Subject: 2013-2014 CX-5 - VARIOUS ELECTRICAL SYSTEM MALFUNCTION(S) RELATED TO C-15 CONNECTOR CORROSION	Bulletin No: 09-041/15
	Last Issued: 10/14/2015

- This bulletin supersedes the previous bulletin 09-005/14, issued on 01/14/14, 02/07/14, 03/14/14, 05/08/14 and 09-031/13, issued on 11/11/13. The REPAIR PROCEDURE, PART(S) and WARRANTY INFORMATION has been revised.
- Changes are noted below in Red beside the change bar.

MASS PRODUCTION CHANGES:

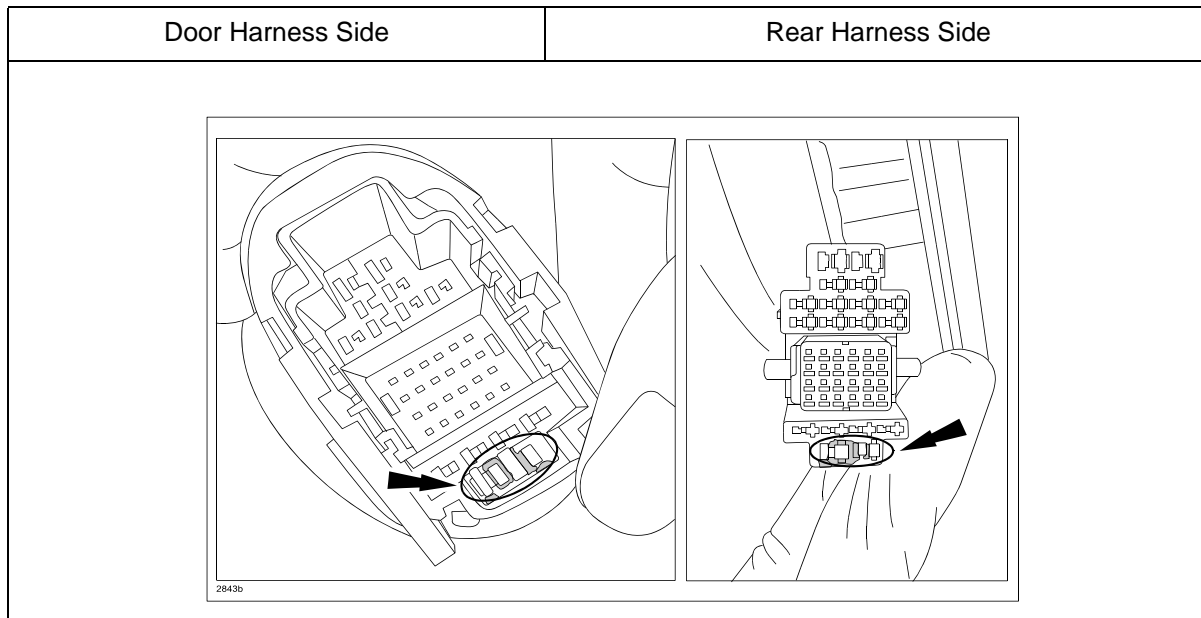
- The front door harness grommet has been changed to improve sealing performance.
- Holes inside the front pillar (which are made for weight reduction), have been covered to prevent water intrusion.
